RE: West Elk Mine (Permit No. C-1980-007) Technical Revision No. 150 (TR-150), Revision to Layout of E-Seam Panels (HC# 68249)

Re: West Elk Mine (Permit No. C-1980-007)
Technical Revision No. 150, (TR-150)

Figure 1

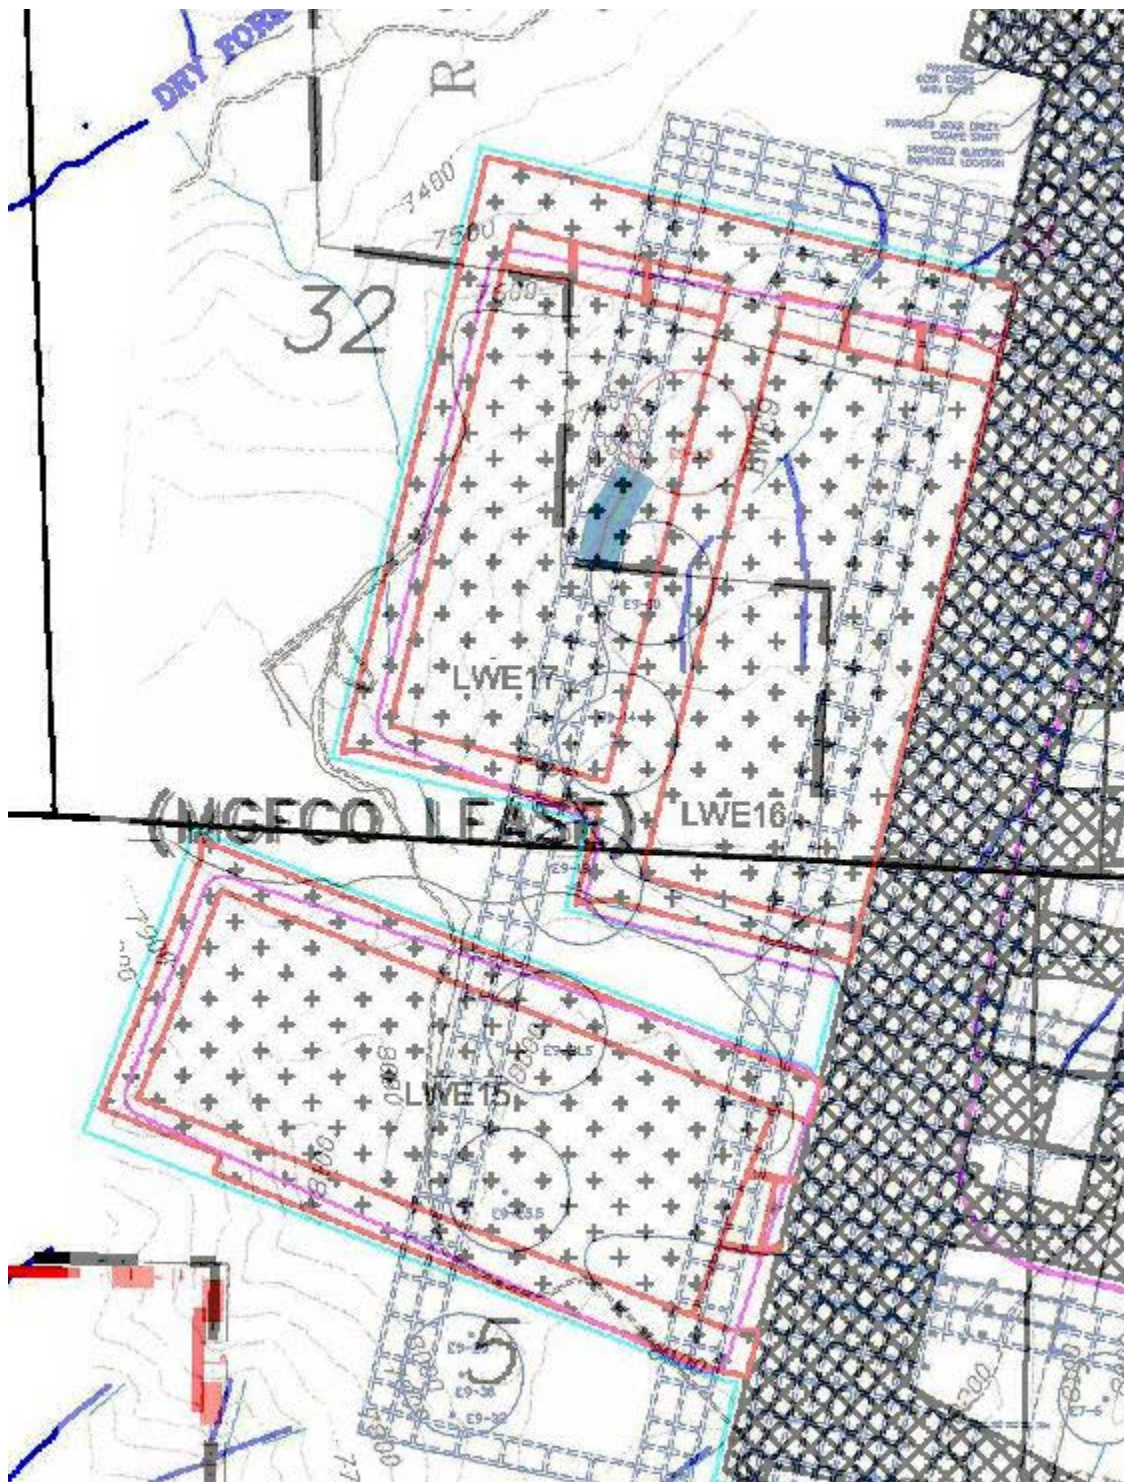
Figure 1 (below) shows a screenshot from my GIS software of the previously approved panel LWE9 overlain on the proposed LWE15-17 (outlined in red). Although the image is indistinct, it allows a quick comparison of the previously approved layout with the newly proposed panels. The six circles with dark outlines show the previously approved locations for MVB pads on panel LWE9, and were surveyed for cultural and historical resources with PR-14 (the red circle was approved but not surveyed).

I am satisfied that the requirements of Rule 2.04.4 - Cultural and Historic Resource Information have been satisfied for TR-150. No new material has been submitted for your review.
